MFN 06-464

Subject: **Response to Portion of NRC Request for Additional Information
Letter No. 67 Related to ESBWR Design Certification Application –
DCD Section 3.9 – RAI Numbers 3.9-4 through 3.9-11, 3.9-17, 3.9-18,
3.9-23, 3.9-26, 3.9-27, 3.9-29, 3.9-32, 3.9-34 through 3.9-36, 3.9-38
through 3.9-40, 3.9-44, 3.9-46 through 3.9-55, 3.9-57, 3.9-59, 3.9-60,
3.9-67, 3.9-72 through 3.9-76, 3.9-79, 3.9-80, 3.9-91 through 3.9-94,
3.9-96 through 3.9-99, 3.9-101, 3.9-102, 3.9-104, 3.9-105, 3.9-108, 3.9-
110, 3.9-132, 3.9-140, 3.9-142, 3.9-147, 3.9-150, 3.9-151, and 3.9-153**

MFN 06-464

DCD Section 3.9

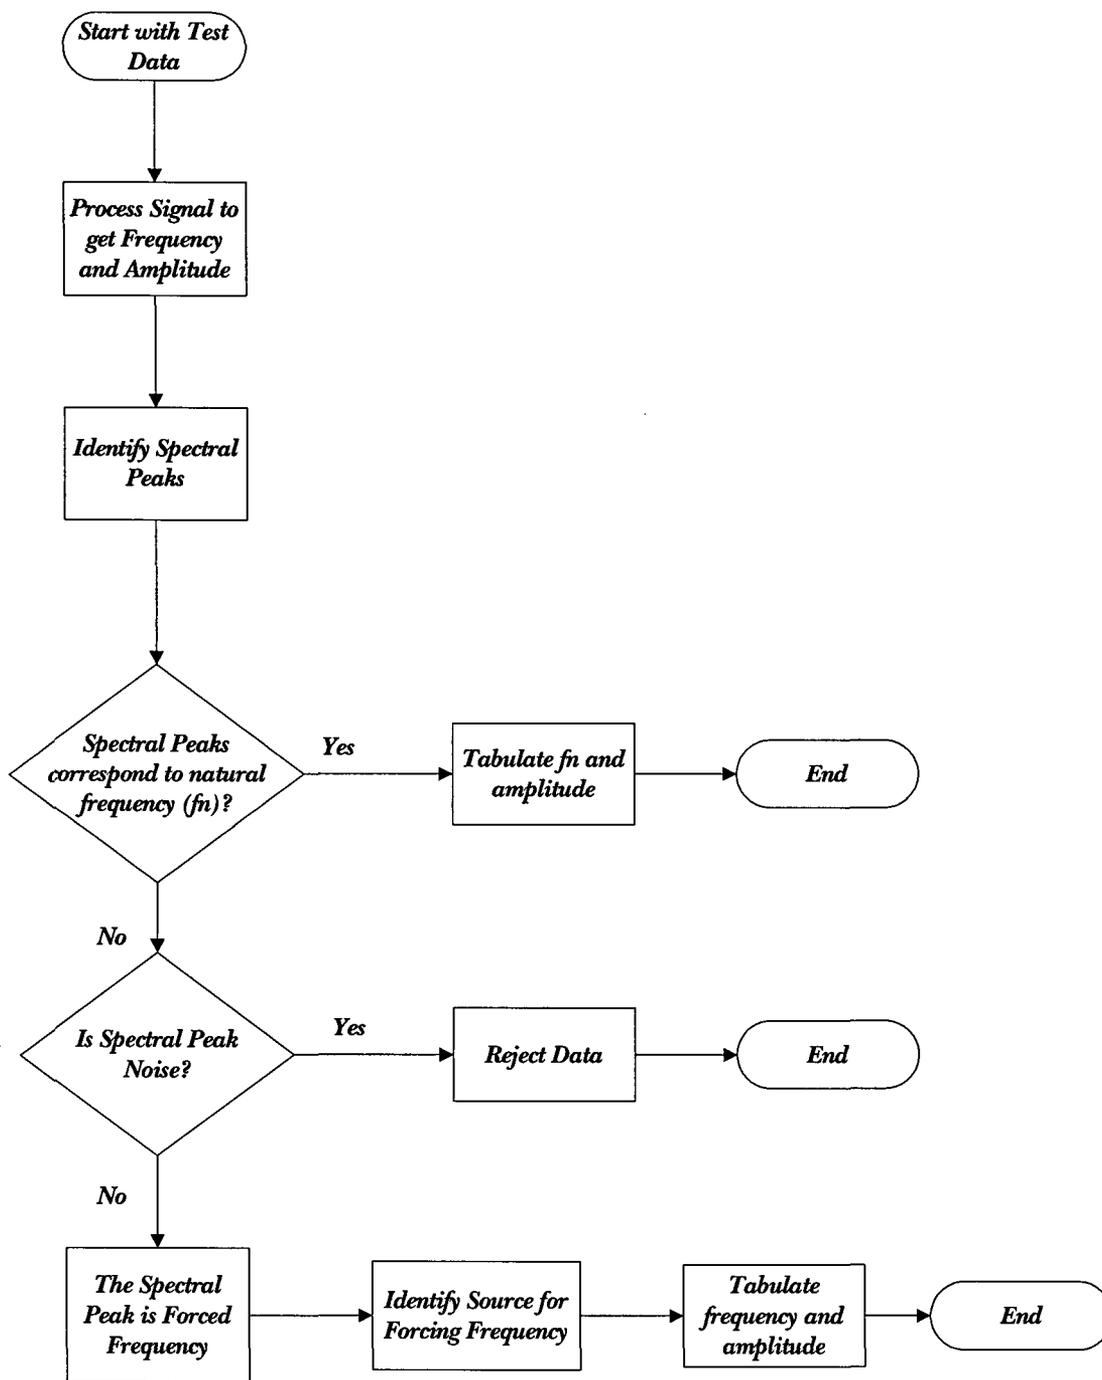
It is stated in DCD Tier 2, Section 3.9.2.3 that special analysis of the response signals measured from reactor internals of many similar designs is performed to obtain the parameters, which determine the amplitude and modal contributions in the vibration responses. Identify the specific parameters which are used to determine amplitude and modal contributions and explain with typical diagrams how these parameters are used in the special analysis.

GE Response

The modal amplitudes and the forced response amplitudes are then used to calculate the expected ESBWR amplitudes for the same component. These ESBWR expected amplitudes are determined by calculating the expected changes in the forcing function magnitudes from the test component to the ESBWR component. For example, for flow turbulence excited components, the magnitudes are determined by ratioing with the flow velocity squared.

A flow chart of the above process is shown below.
